Appendix G: RFLMA Contact Records

ROCKY FLATS SITE REGULATORY CONTACT RECORD

Purpose: Targeted soil sampling at the Original Landfill (OLF) to evaluate residual contamination levels in relation to the Colorado Department of Public Health and Environment's (CDPHE's) August 2008 Policy, *End of Post-Closure Care*.

Purpose: Approval of Excavation Greater Than 3 Feet Below Grade to Breach Dams A-3, A-4, B-5, C-2 and the Present Landfill Dam.

Figure 1. Monitoring and Dam Breach Locations—Woman Creek Drainage Area

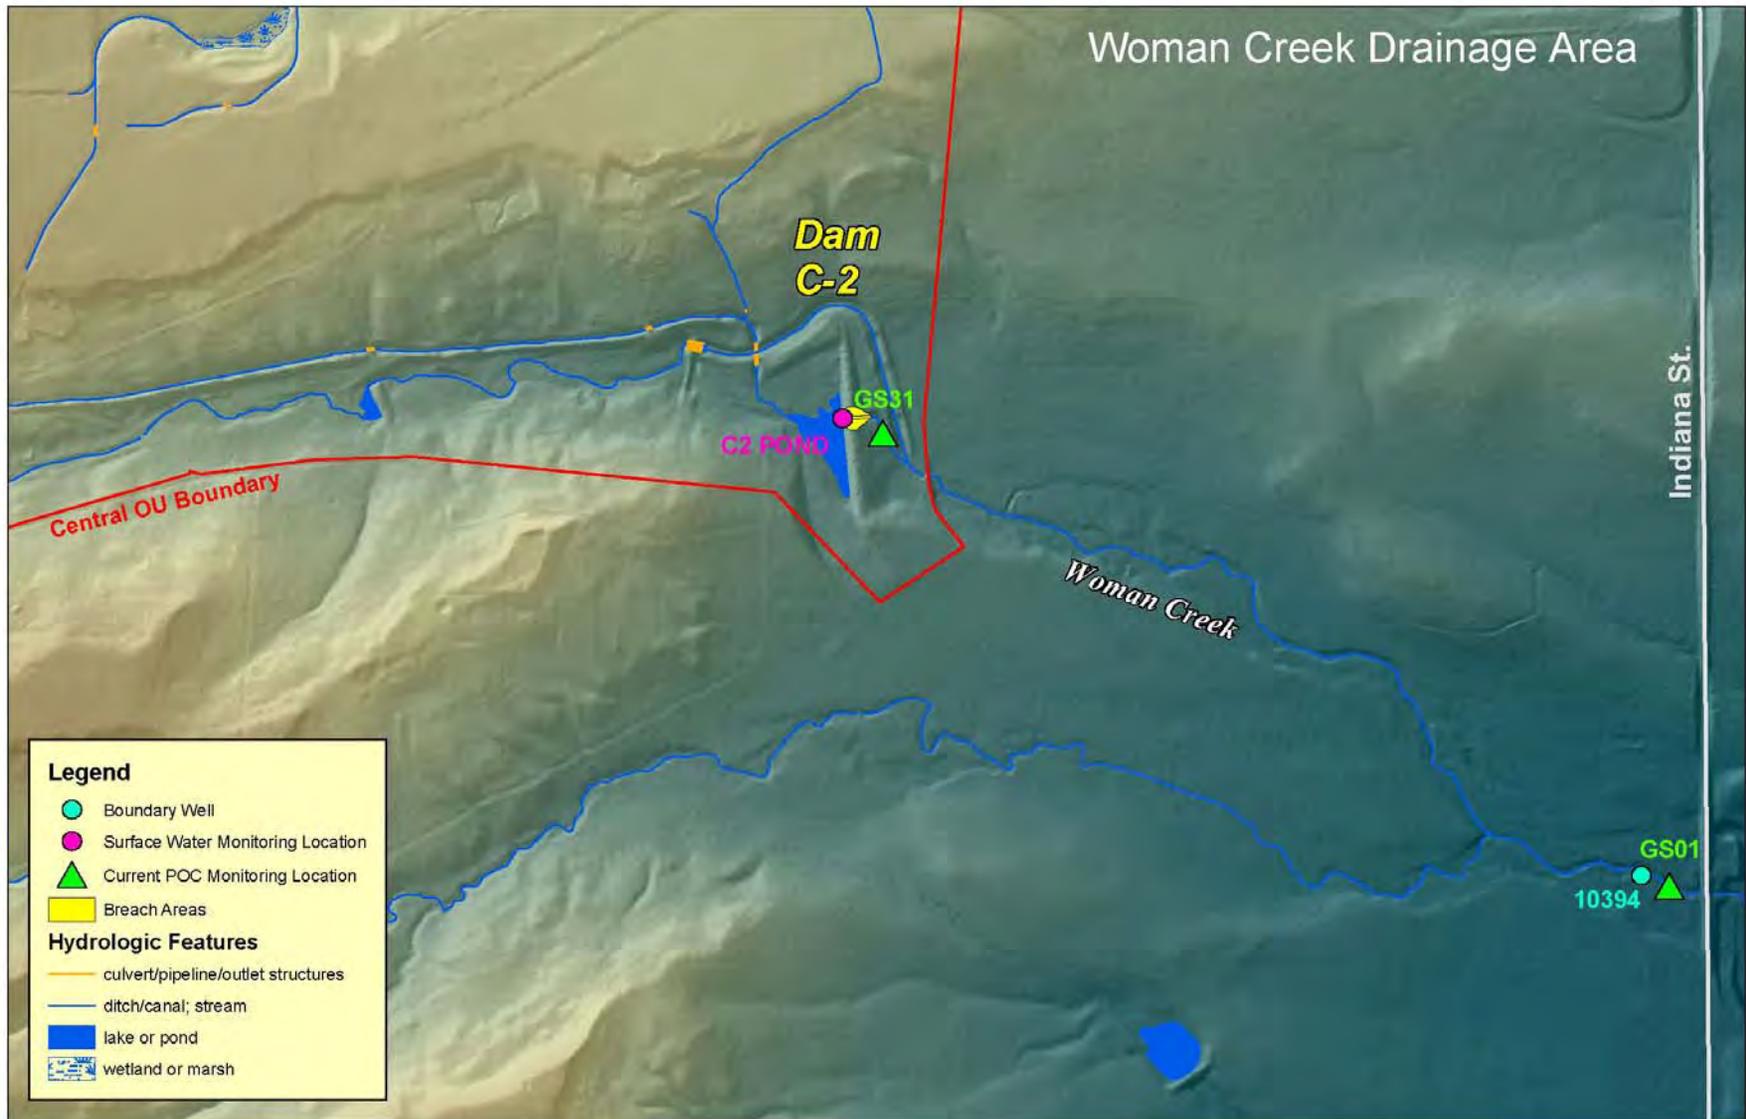
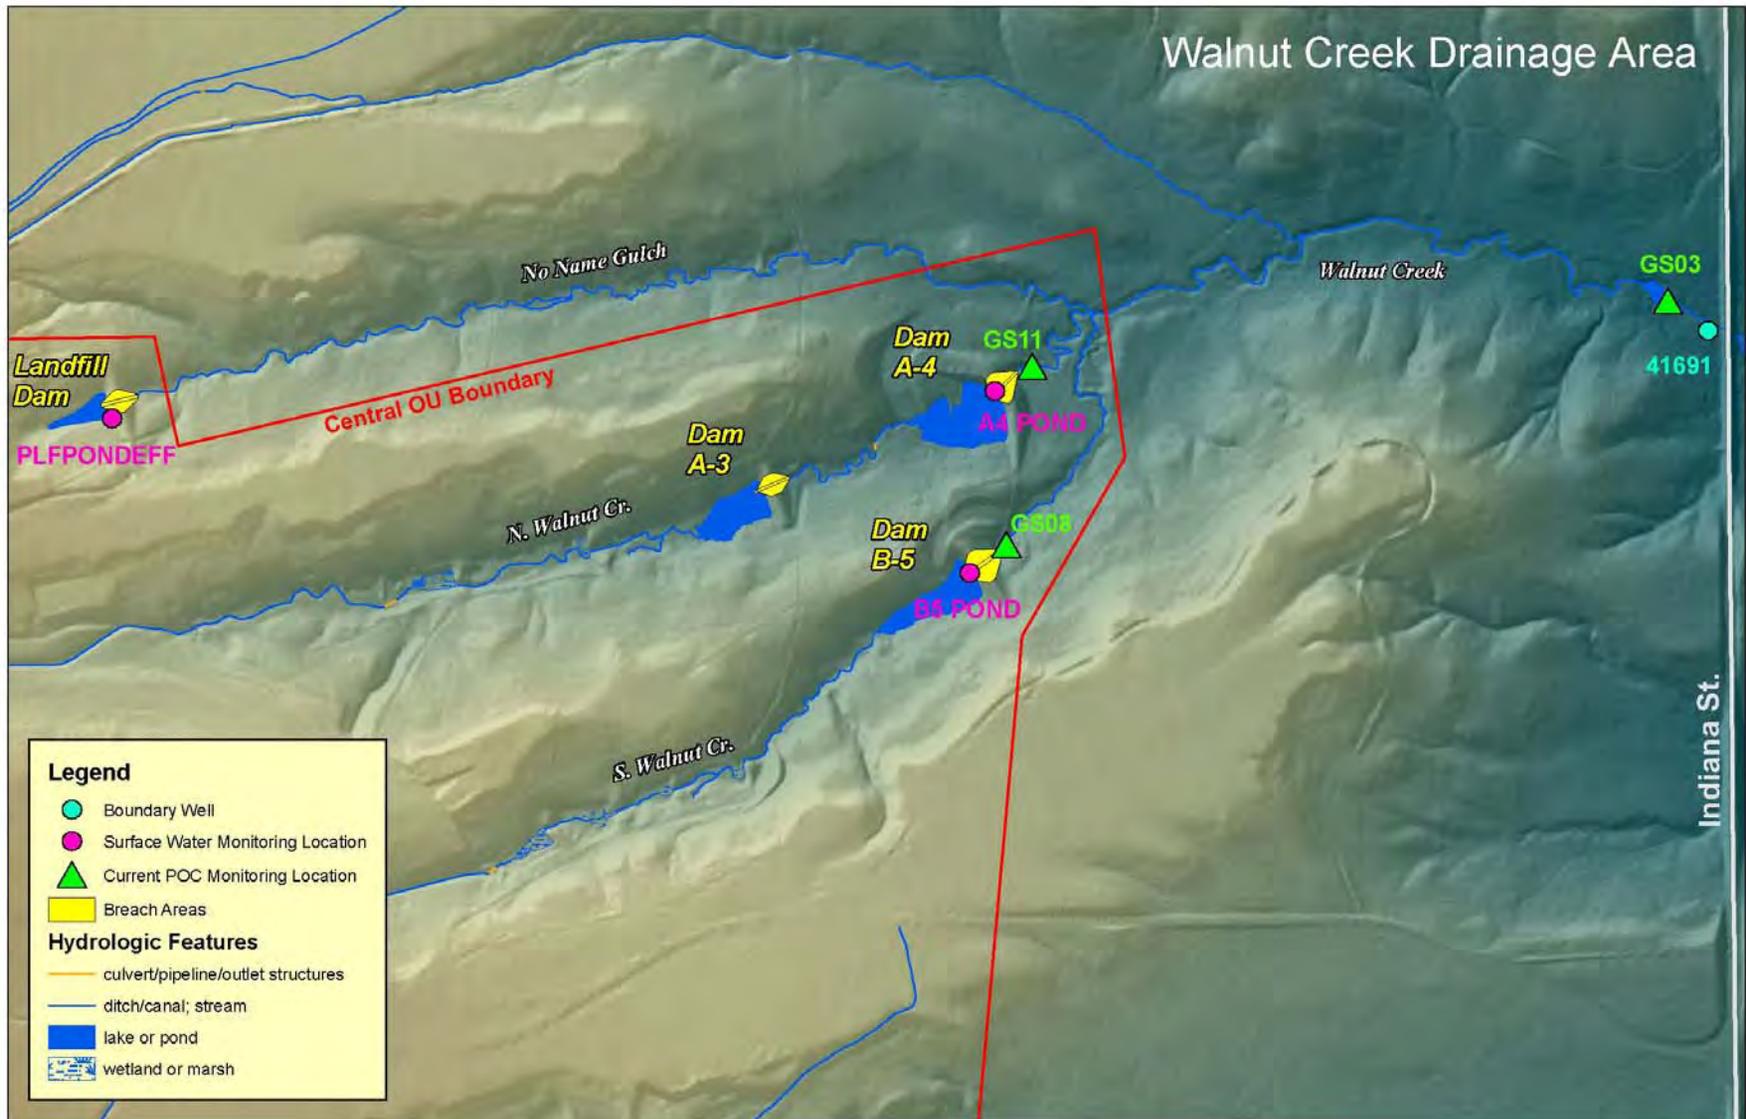
A portion of each dam embankment will be removed to form a channel in the dam and create a flow-through configuration. The designs for the previous dam breach construction included stop log structures in the notch to retain a shallow pool level upstream of the stop logs. The shallow pool level can be adjusted by adjusting the height of the stop logs (by removing or adding stop logs) in the structure. The preliminary design for the breach of the remaining dams does not include stop log

Resolution: Carl Spreng, CDPHE, approved the soil excavation for the proposed dam breach work.

Figure 1. Monitoring and Dam Breach Locations—Woman Creek Drainage Area

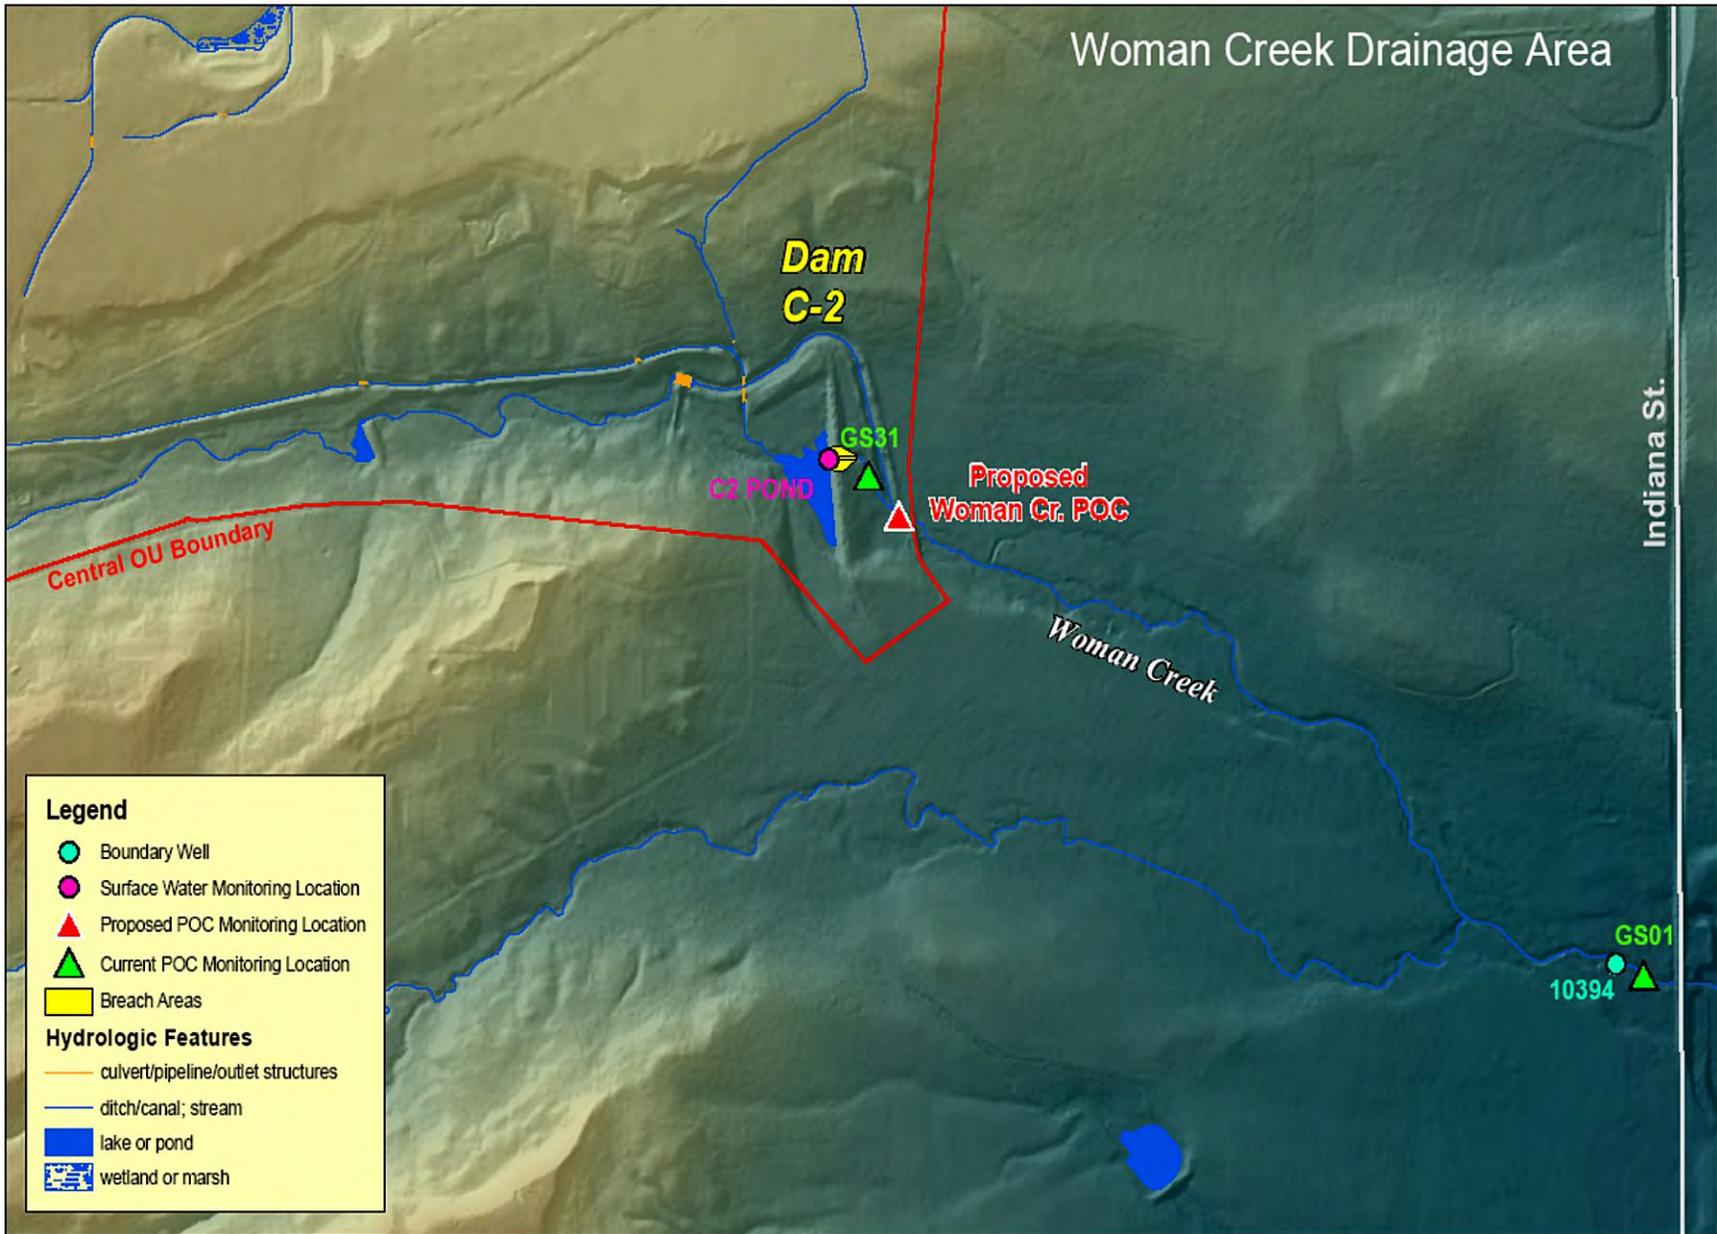
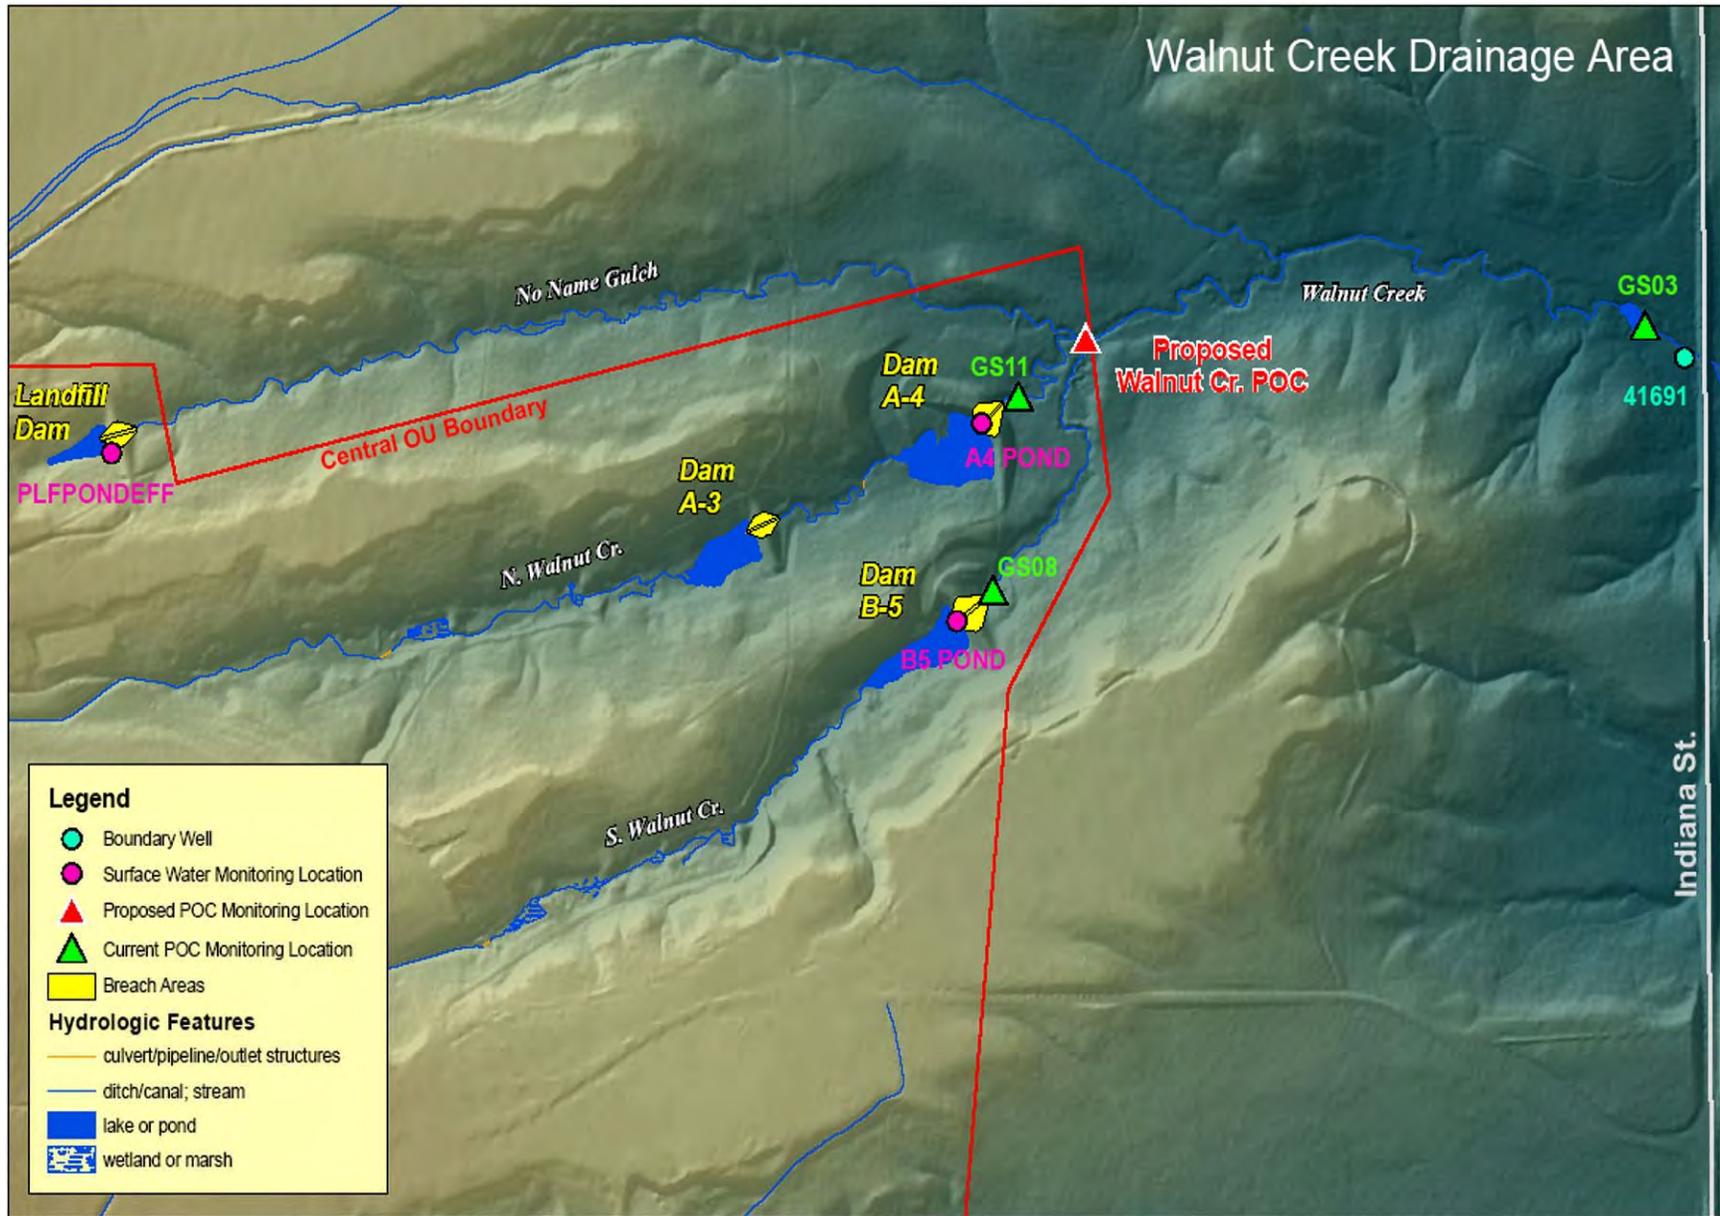
Figures 1 and 2 in this Contact Record also show the current required monitoring locations, the monitoring locations that DOE proposes to eliminate, and DOE’s proposed new monitoring locations. The relevant monitoring locations are listed in Table 1 as well. Figures 1 and 2 also show the locations of the remaining ponds and dams and the approximate footprints of the construction areas for the proposed dam breach based on the preliminary design used in preparing the EA.

Resolution: Carl Spreng, CDPHE, approved the summary of the consultation provided by this Contact Record documenting the approach for the proposed modification of monitoring locations. The soil excavation for the new flumes may also be conducted as described in the Contact Record.

Figure 1. MSPTS (left photo), ETPTS (right photo), and approximate locations of extra sampling points with respect to treatment systems and surface water performance locations. Source photos are from 2010.

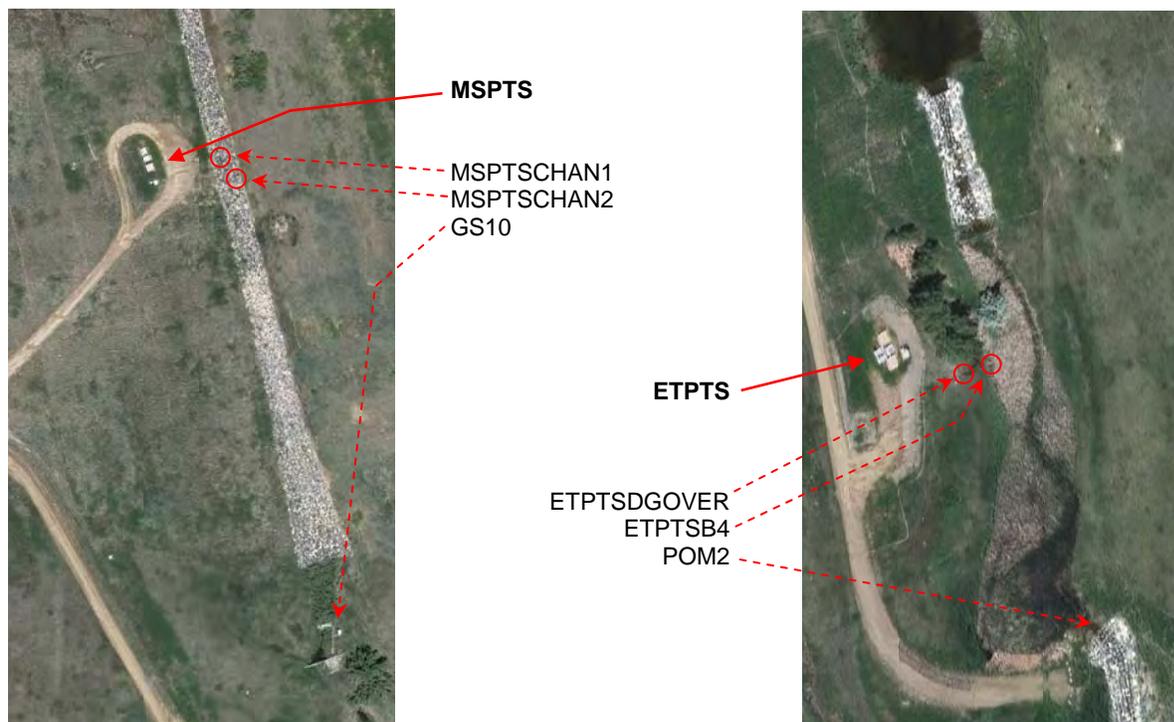
On June 17, 2010, potential sampling locations at the MSPTS and ETPTS were identified. At the MSPTS, the two locations represent water within Functional Channel (FC)-4; one is closer to the effluent discharge gallery and is identified as MSPTSCHAN1. On June 17, this location held what appeared to be standing water (i.e., active flow was not apparent). The second location at the MSPTS, MSPTSCHAN2, is a short distance down FC-4 from the previous location and represents what appeared on June 17 to be the farthest upstream location at which samples of visibly turbulent, flowing water could be easily collected. The two locations at the ETPTS include ETPTSDGOVER, which is at the discharge gallery; and ETPTSB4, which is where discharge gallery water joins former Pond B-4. Figure 1 below illustrates the general locations of these additional sampling points.

These results demonstrate that residual VOCs in system effluent dissipate very quickly, and would not represent a threat to surface water quality at surface water Points of Compliance. However, DOE is evaluating optimization of the MSPTS to provide additional VOC removal. This optimization is currently conceived as a passive air stripping component. The parties will continue to consult to finalize optimization of system performance to encourage additional VOC removal.
